CITY OF CALLAWAY
FIBERGLASS LIFT STATION INSTALLATION
BID NO.: CM2022-01

ADDENDUM #1

Date Issued: January 19, 2022

C-100	EXISTING CONDITIONS PLAN		PROJECT NO. 27656.01	NO. 1	DATE 01/2022	APPR. JEA	REVISION/ACTION TAKEN ADDENDUM 1
			DESIGNED BY: TFL				
			DRAWN BY: JEA				
			CHECKED BY: JEA				
			PROJECT MGR: JCP				
		DATE: SEPTEMBER 2021	NOT RELEASED FOR CONSTRUCTION BY		DATE

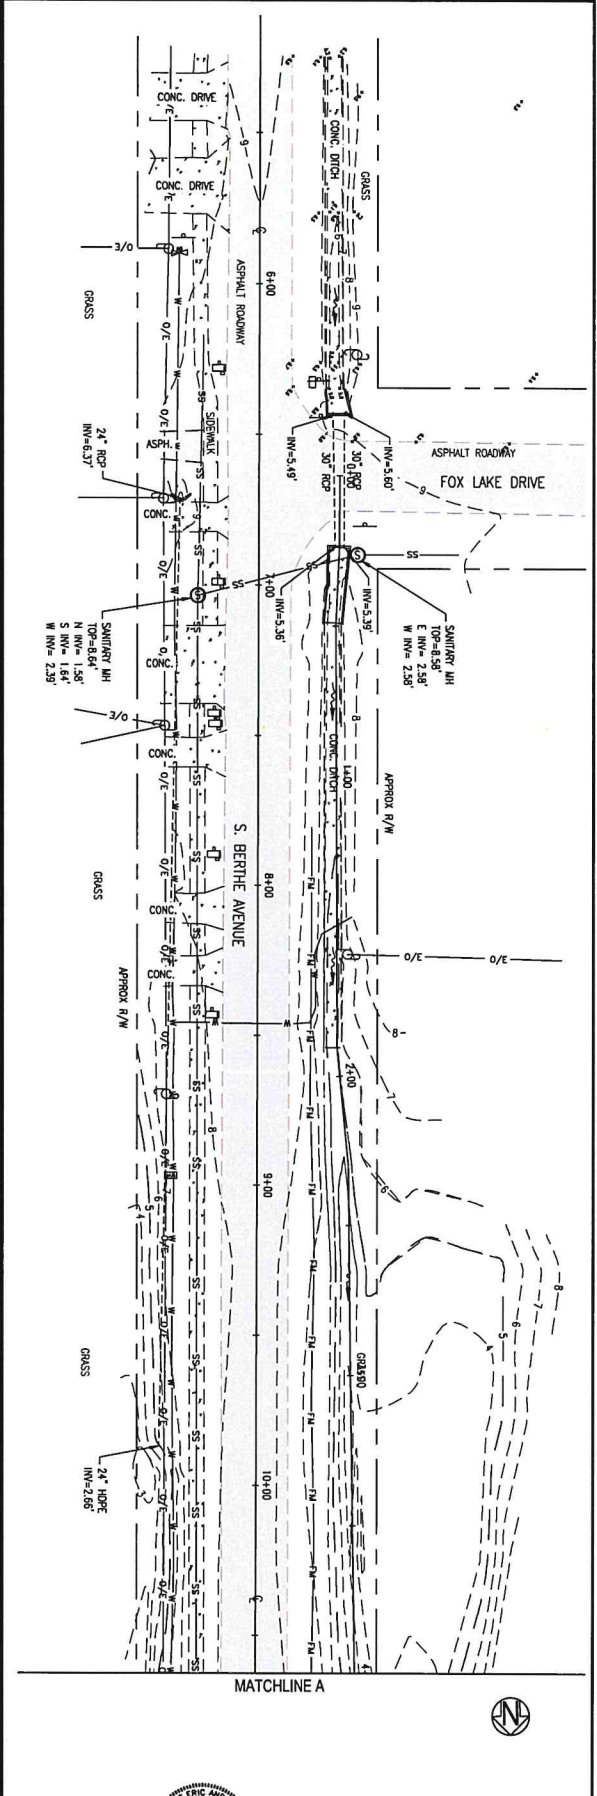
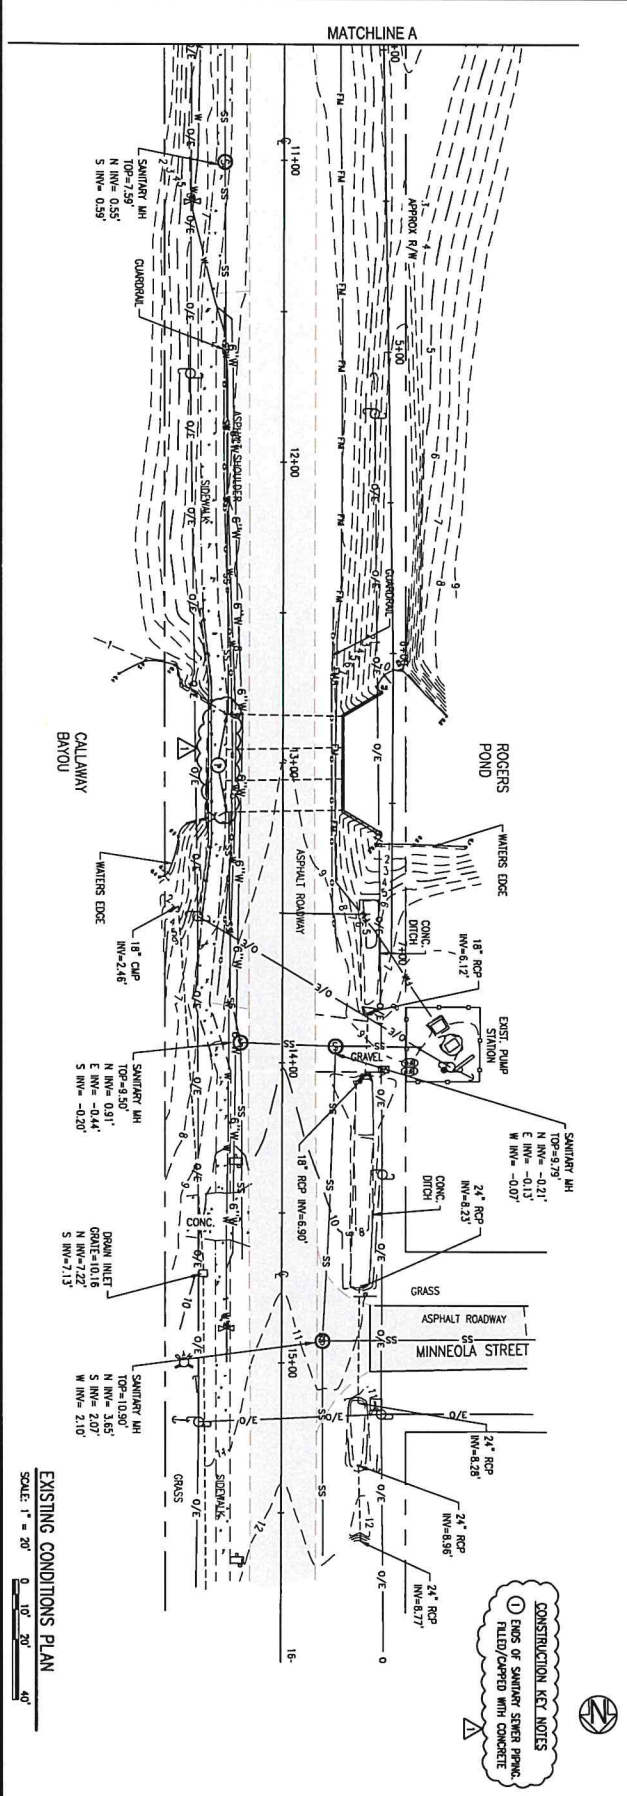
- 1. **Sheet C-100:** The existing condition plan was updated accordingly. The City of Callaway removed the sanitary sewer pipe crossing the Callaway Bayou.
- 2. **Sheet C-101:** Abandoned sanitary sewer piping and manhole demolition (i.e. grout fill, open cut removal, etc.) was removed from the project. Construction Key Notes were updated accordingly.
- 3. **Sheet C-900:** Detail C1, Detail for Abandonment of Existing Manhole On Existing Sewer (Not To Remain In Service) was removed from the construction plans.
